# SERVICE BULLETIN

M1289

## 2006-2011 Touring Models Handlebar Clamp Screw Running Change/CD Skip

**Figure 1. Updated Handlebar Torx Head Fastener with Shorter Head**

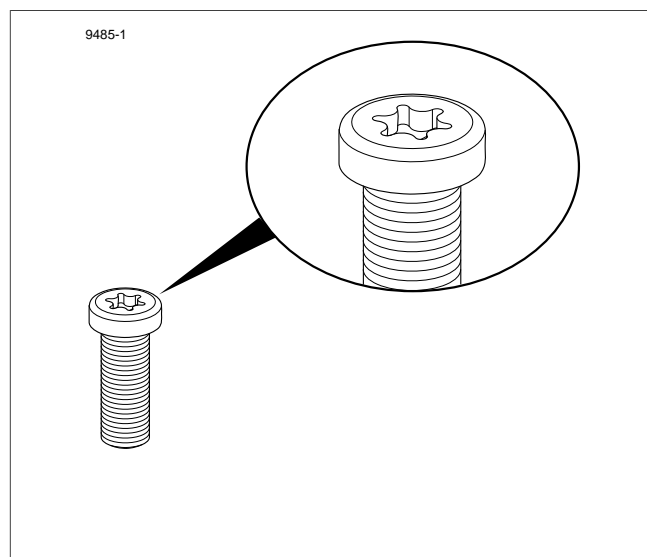
The purpose of this bulletin is to inform dealers of a running change to the fastener used to secure the handlebar clamp to the risers. For all 2011 Touring models built approximately on or after October 7, 2010, a new fastener, (Part No. 12600003), is being implemented in all four locations on the handlebar clamp. On all 2011 Electra Glide Touring models equipped with the Advanced Audio System, the new fastener will provide additional clearance between the two forward handlebar clamp fasteners and the radio chassis. Lack of clearance at this location has been determined to be a major contributor to CD skip and other audio system concerns.

On 2006-2011 Electra Glide Touring models equipped with the Advanced Audio System, if a customer has concerns about CD skip, inspect vehicle for contact between the handlebar clamp screw head and the radio chassis. If contact exists, remove the radio, replace the two forward handlebar clamp fasteners (there will be no kit, the dealer will be required to order two Part No. 12600003 screws) and reassemble following service manual procedures.
